## REQUEST FOR PROPOSALS Boiler Flue Replacements

**DULUTH TRANSIT AUTHORITY**

Addendum #1

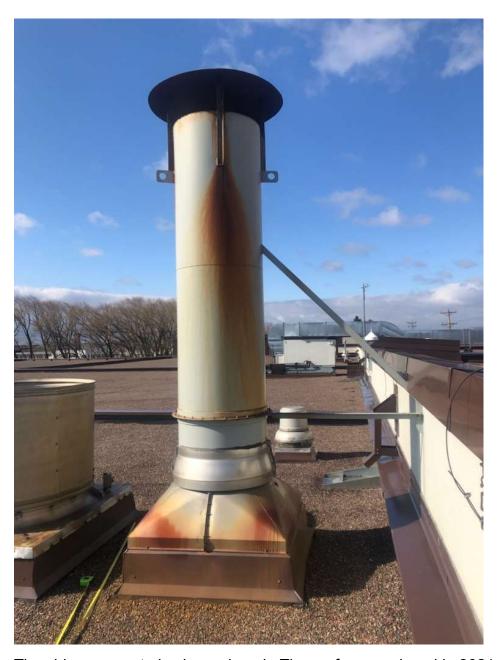
- b. Replacement of the flue will begin at the collar in the boiler room where the double wall flue connects to the exhaust pipe from the boiler (see the picture below.) The distance from the collar to the wall is approximately 63-inches. It is the Contractor's responsibility to verify field measurements.

The replacement flue will begin at the collar where the vent connects to the exhaust pipe from the boiler.

The distance from the collar to the wall is approximately 63 inches.
